<b>MATERIAL:</b>	<b>DWG NO:</b> JFCB3400T3600SF			
	<b>SURFACE TREATMENT:</b> PAINTED BLACK	DWG BY: LJ.Zhang	01.16.2015	SCALE
<b>DESCRIPTION:</b> FILTER	CHK'D BY:			1:1.5
	APPV'D BY:			
	Unit: mm[inch]	Tolerance: Liner: ±0.25 Anguar: ±0.5°	The First:

<b>JQL Electronic Inc</b>				
<b>MATERIAL:</b>		<b>DWG NO:</b> JFCB3400T3600SF		
<b>SURFACE TREATMENT:</b> PAINTED BLACK		DWG BY:	LJ.Zhang	01.16.2015
<b>DESCRIPTION:</b> FILTER		CHK'D BY:		SCALE
		APP'V'D BY:		1:1.5
Unit: mm[inch]		Tolerance: Liner: ±0.25 Anguar: ±0.5°	The First:	
				A4

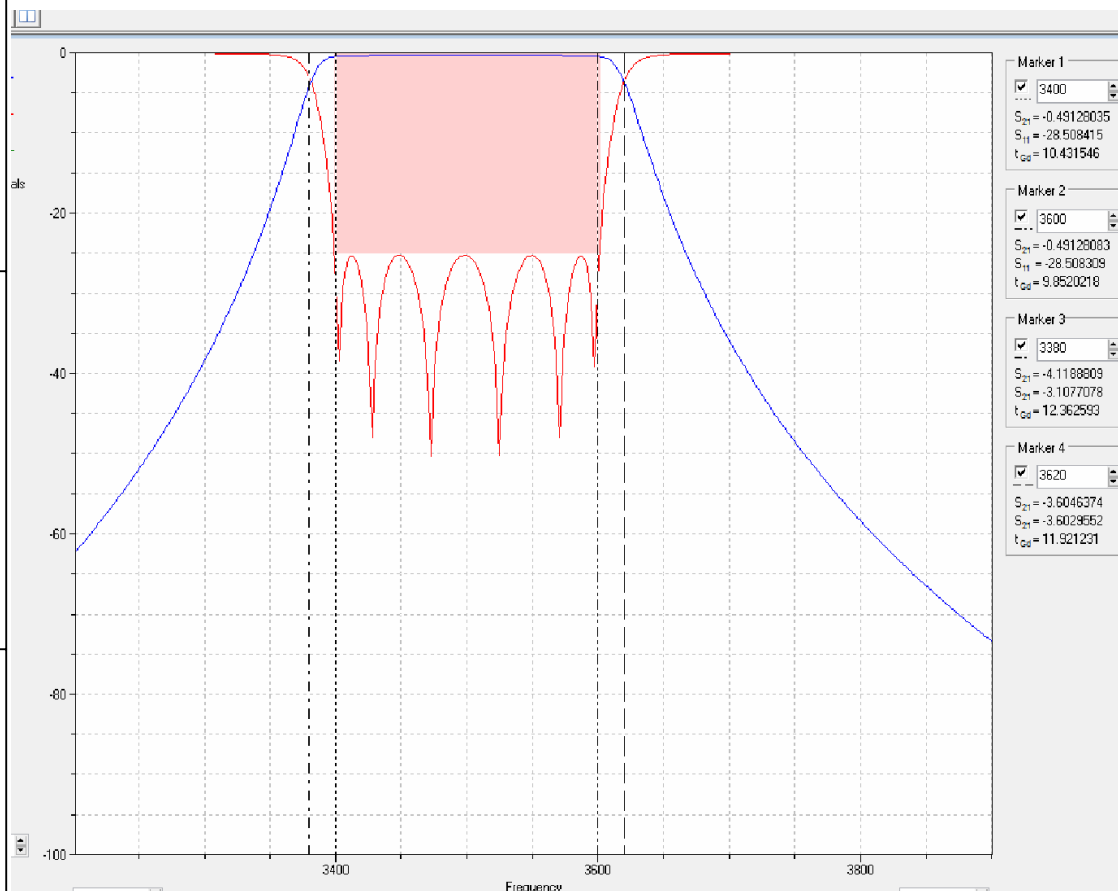
ITEM	SPECIFICATIONS	Maker Proposal Specification
Frequency(MHz)	3400~3600	OK
Insertion Loss(dB)	0.5 Max@Room Temperautre 0.7 Max@-40~+85 °C	OK
Return Loss(dB)	17.7 Min	OK
Rejection(dB)	40 Min@DC~3080 MHz 25 Min@3080~3230 MHz 15 Min@3230~3380 MHz 15 Min@3620~3770 MHz 25 Min@3770~3920 MHz 40 Min@6800~7200 MHz 40 Min@10200~10800 MHz	40 Min@DC~3080 MHz 25 Min@3080~3230 MHz 25 Min@3770~3920 MHz 40 Min@6800~7200 MHz 40 Min@10200~10800 MHz
Power (Watt)	50 Min@Power handing CW 200Max@Peak power handing during 10uSec	OK
Input/Out put Impedance(Ω)	50	OK
Operating Temperature(°C)	-40~+85	OK
Connector	SMA-Female	OK
Additional Notes	-
